NUMBER: B090R1166-0

SERVICE BULLETIN

Subject: REPLACEMENT OF THREE-
POSITION SWING KNOB SWITCH

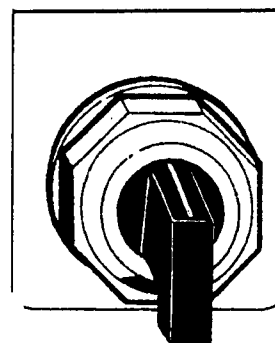
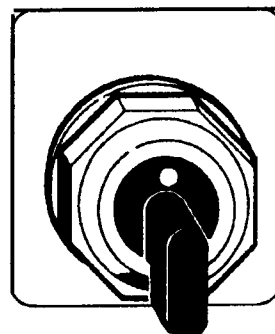
Chance Rides, Inc. has determined, through field experience that the three-position swing knob switches used on many Chance Rides, Inc. products may not meet our specifications. These swing knob switches are located on the operator's control panel and can be identified as those knobs which have three positions, the center position being the neutral position with the knob automatically returning to that position by means of a spring. These swing knob switches require routine inspection to insure the spring is functioning properly in returning the knob to the center position. If the spring breaks, the knob will not return to the center position. If the knob does not return to the center position, the ride may not function as the operator expects, resulting in possible injury to the operator, attendants and/or passengers.

Chance Rides, Inc. is now using a new three-position swing knob switch and requires all owner/operators of Chance Rides, Inc. products with three-position swing knob switches to order and install the new replacement knobs and mating contact blocks. Refer to the chart on this bulletin to help identify those rides having swing knob switches which need to be replaced, along with the quantity of swing knob switches and the number and kind of contact blocks required for each ride as well as the appropriate part numbers for each item. The cost of these new style swing knob switches and contact blocks will be credited back to the purchaser if the old style swing knob switch is returned to Chance Rides, Inc. within ninety (90) days of the date on this bulletin.
